ANDREWS 115 kV SUB-STATION - UPGRADE

IESO EXPEDITED SYSTEM IMPACT ASSESSMENT – CAA ID 2005-EX248

EXPEDITED SYSTEM IMPACT ASSESSMENT REPORT – CAA ID 2005-EX248

FIGURE 1B : PROPOSED ARRANGEMENT IN ANDREWS GS

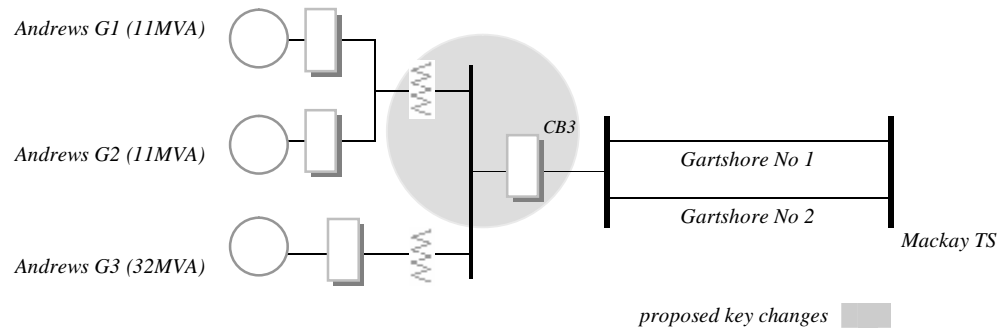
Currently, each of the generators has its own step-up transformer. The owner of the station, Brascan Power Corporation has informed the IESO that they will replace the existing step-up transformers of G1 and G2 with a new single step-up transformer and the two oil circuit breakers CB1 and CB2 with a new SF6 breaker CB3 as shown in Figure 1B.

The 12 kV and 115 kV disconnect switches located on either side of the step-up transformers will also be replaced with new air break switches. In addition, a new transformer protection will be installed and the revenue meter will be relocated between the common 115 kV bus and the new circuit breaker CB3.

Presently, the three step-up transformers in Andrews GS are accompanied by two 115 kV breakers. Thus, for a transformer fault, only a part of the generation would be lost. However, with the proposed arrangement, there would be only a single 115 kV breaker and this would increase the exposure for loss of entire generating station for a fault at a transformer or any local 115 kV busbar. Since, traditionally the fault incident rate for transformers and buses has been very low, the proposed installation of the new transformer is not expected to have any material impact on the reliability of the IESO-controlled grid.

2. The Market Rules require that for northern Ontario, the equipment with 115 kV nominal rating must have the capability to operate continuously at system voltages between 113 kV and 132 kV. The proponent must confirm whether the 115 kV winding of the new transformer and all new interrupting devices comply with this standard.

3. The Transmission Code requires that all 115 kV equipment to be rated to 50 kA for phase to ground and 3-phase fault level. The rated 3-phase short circuit level of the proposed breaker is only 40 kA. If any future system modification will result in an increase of the short circuit level in the area beyond 40 kA, the proponent will be required to replace the breaker with a higher rated unit.

ROTOR ANGLE OF ANDREWS G1 OR G2

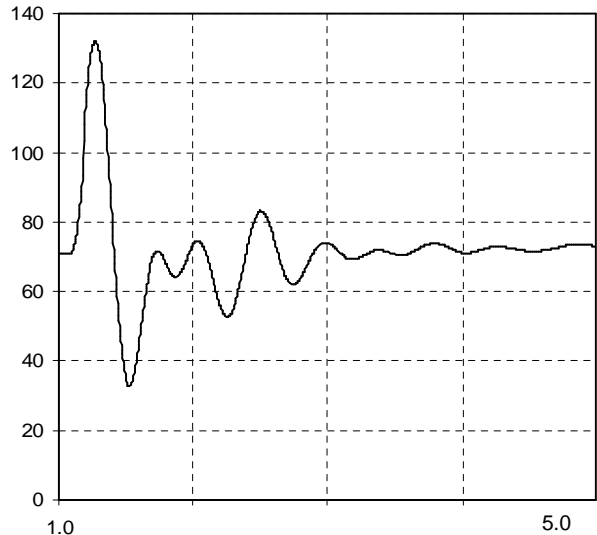
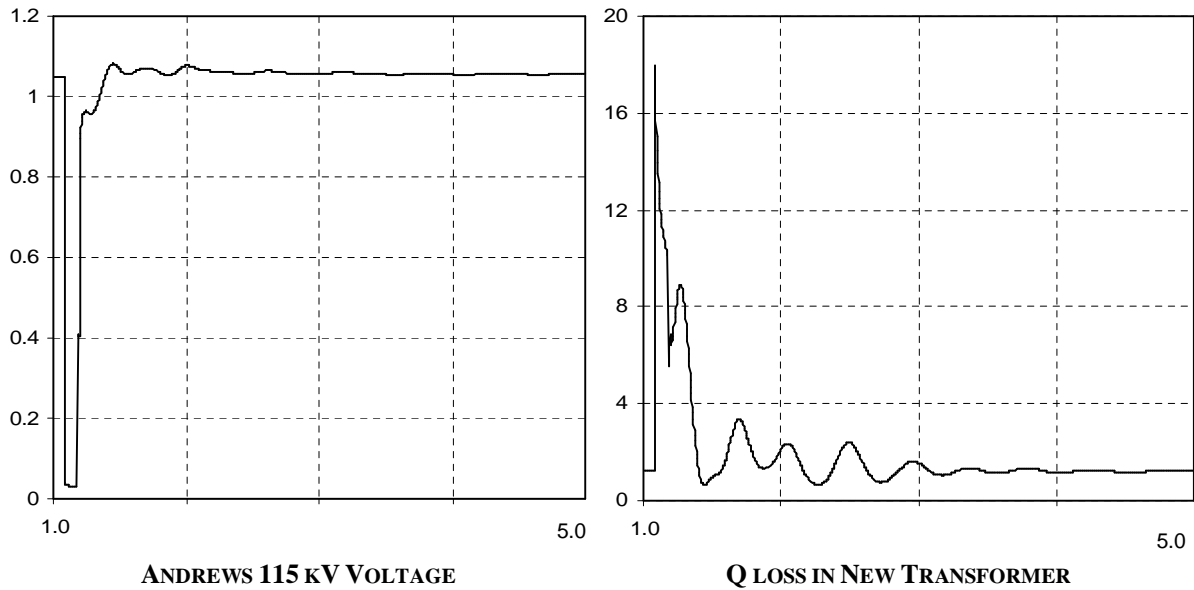
The results of the transient stability studies show that the post-fault transients of the rotors appear to be sufficiently damped. Therefore, the impedance of the proposed transformer does not seem to have any detrimental effect on the stability of the generators.

Further, the initial transient surges/drops are expected to be shorter than shown above for line-to-ground faults that are normally used to test the performance of generators in northwest region of the IESO-controlled grid.
